Process Sheet

Customer : CU-DAR001 Dart Helicopters Services	Drawing Name : PAD
Job Number : 27324	
Estimate Number : 11203	
P.O. Number : N/A	Part Number : D31955
This Issue : 6/1/2006 S.O. No. : N/A	Drawing Number : D3195 REV A
Prsht Rev. : NC	Project Number : N/A
First Issue : N/A Type : SMALL /MED FAB	Drawing Revision : A
Previous Run : 26159	Material : N/A
Written By : <u>See comment below</u>	Due Date : 6/8/2006 Qty: 50 Um: Each
Checked & Approved By : <u>W</u>	
Comment : Est Rev:A New Issue 05-12-05 JLM

From: Chris Provencal [mailto:cprovencal@dartaero.com]
Sent: Thursday, June 01, 2006 1:16 PM
To: davids@dartaero.com
Subject: D3195 pad change

D3195-5 & D3195-7 PAD

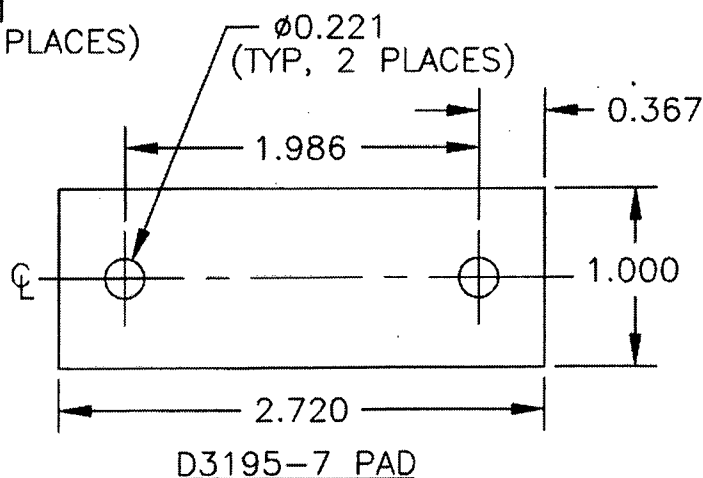
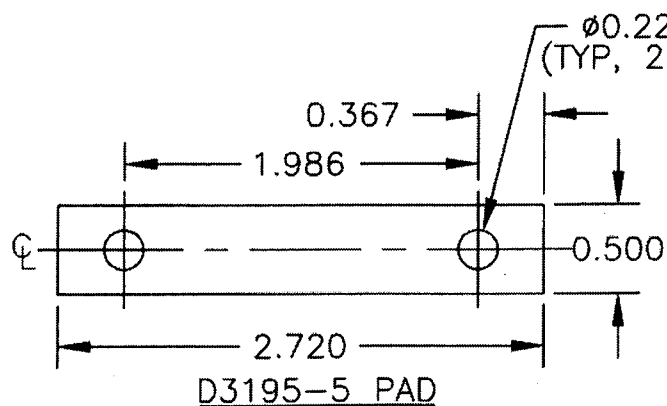
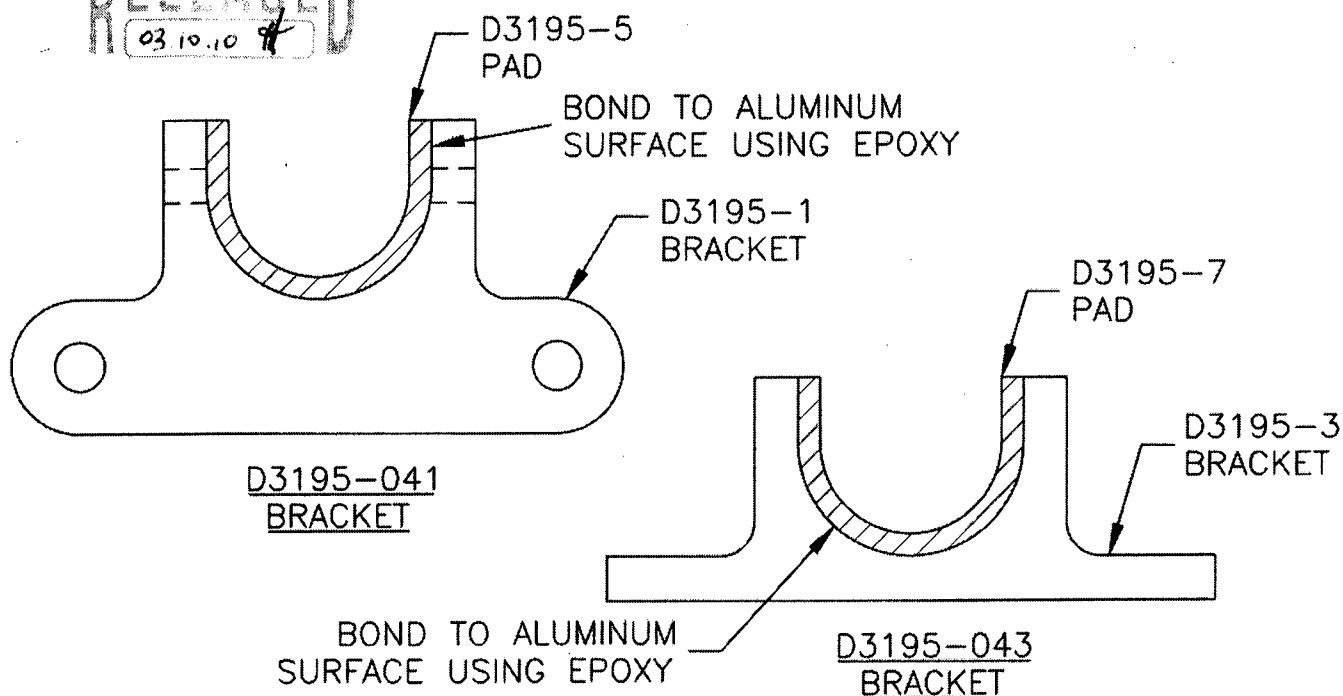
W/O:		WORK ORDER CHANGES					
DATE	STEP	PROCEDURE CHANGE	By	Date	Qty	Approval Mfg / Design Mgr	Approval QC Inspector
06.06.01	Z	Cut D3195-S PAD so that it is flush with the edges of the D3195-1 BRACKET. TRANSFER LOCATION of Ø0.221 holes to from D3195-1 to D3195-S (see DS email attached)	SB	06/07/19	50	 06.06.01 per 071642

The D3195-5/-7 Pads should be 2.50" long instead of 2.720". Sylvie showed me the parts and I agree.

If made to drawing they are too long. In the past they've done them to fit the brackets (2.50" long and making the holes by transferring the location from the brackets).

For this batch they should have a signed-off change to the work order. I will instruct them to cut the length to be flush with the bracket and transfer the location of the hole from the D3195-1/-3 brackets. Is this change OK?

Obviously, this is an acceptable deviation.

I will measure some of the final parts to update the dwg.
